No: 26-076

Dauphin County Subdivision/Land Development Review Report

Municipality	City of Harrisburg	Surveyor	Terra Viz, Inc.	Engineer	LIVIC Civil, LLC
Plat Title	1257 & 1259 Walnut Street P/F Land Development and Lot Consolidation Plan				
Zoning District	Residential Medium Density District (RM)	Proposed Land Use	Multi Family Residential

Project Description: To construct an innovative, multi story residential structure

SITE LAYOUT PLAN

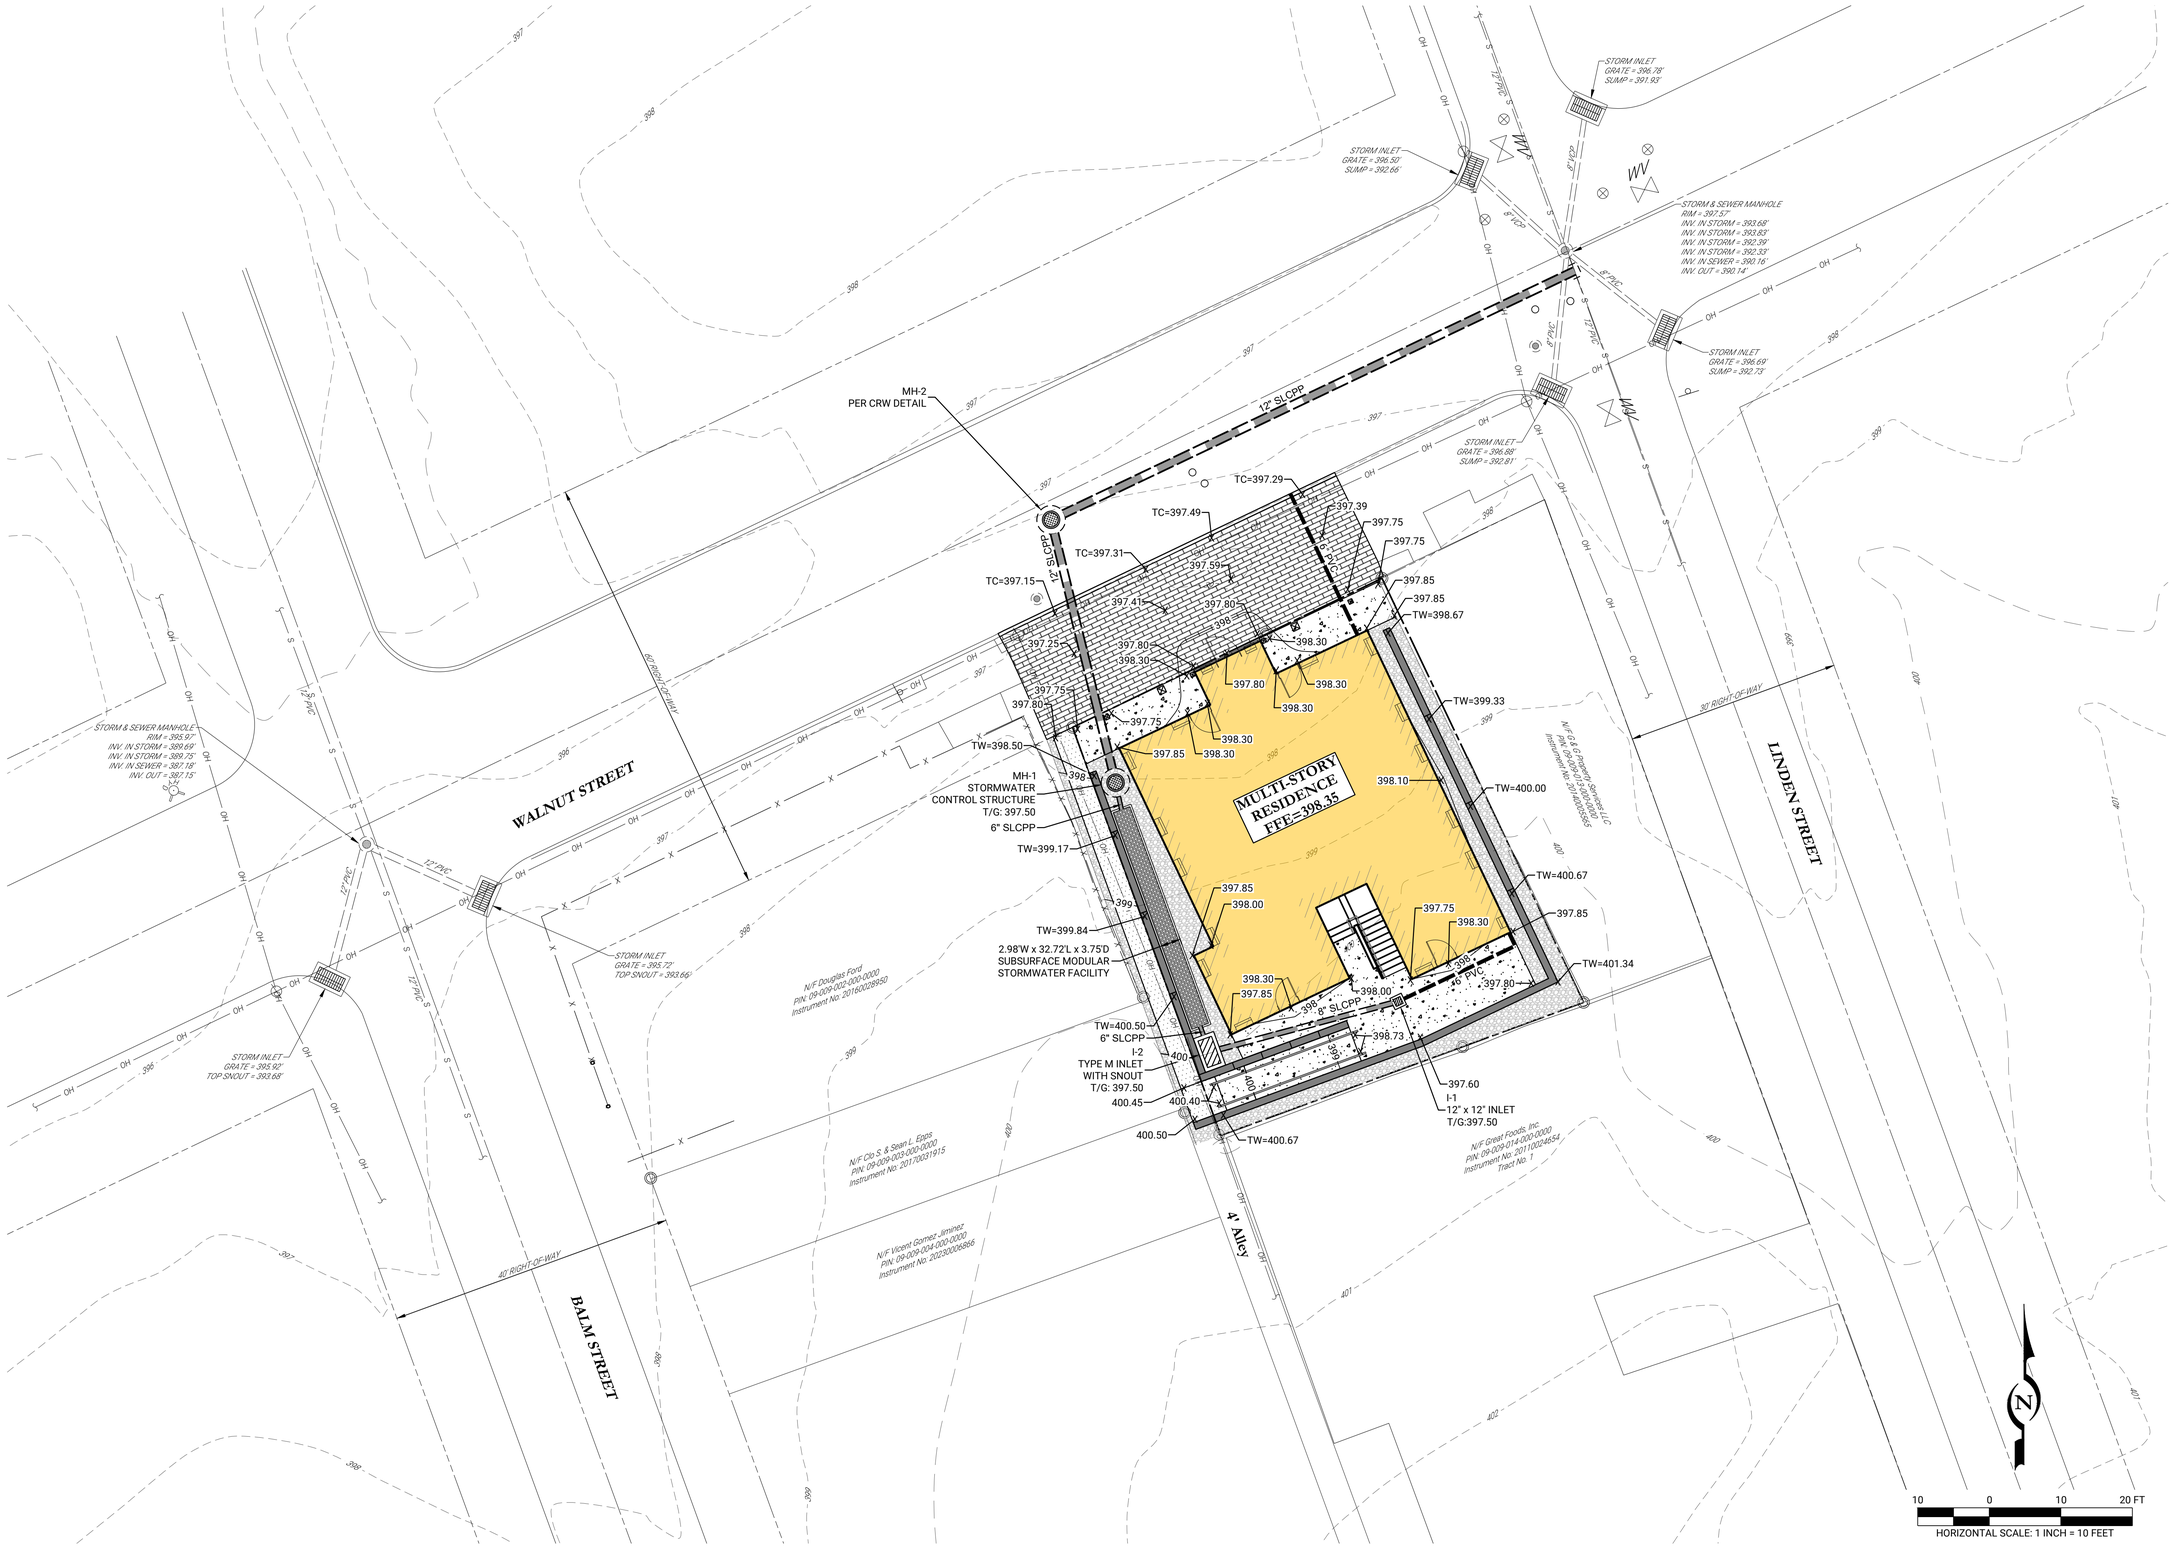
2. In addition, provided are some general observations:
    a. The submitted plan appears to propose the consolidation of two existing parcels into a single lot. The plan also indicates a permeable pavement area intended to serve both as a sidewalk and as a stormwater management feature. It is assumed that this improvement is being provided to satisfy the applicable requirements for both functions. However, the permeable pavement area appears to be located within the Walnut Street right-of-way. It is unclear whether this improvement is intended to become the City's responsibility for long-term maintenance and upkeep. The plan does not identify any easements, maintenance agreements, or notes that address ownership and long-term maintenance responsibilities for this feature. Clarification should be provided.

* See note regarding permeable paver

Pavers to serve as storm water controls?

(K)(iii)	volumes and discharge curves with corresponding water surface elevations, inflow hydrographs, and outflow hydrographs See previous note regarding stormater and pavers
76	X	☐	☐	505.10(8) (K)(iv)	Guidelines for lot grading within the subdivision, identifying the direction of stormwater runoff within each lot, and the areas where runoff will be concentrated (show using topographic data)
77	☐	X	☐	505.10(8) (K)(v)	Soil characteristics report and information on erosion and sediment control from the Dauphin County Soil and Water Conservation District
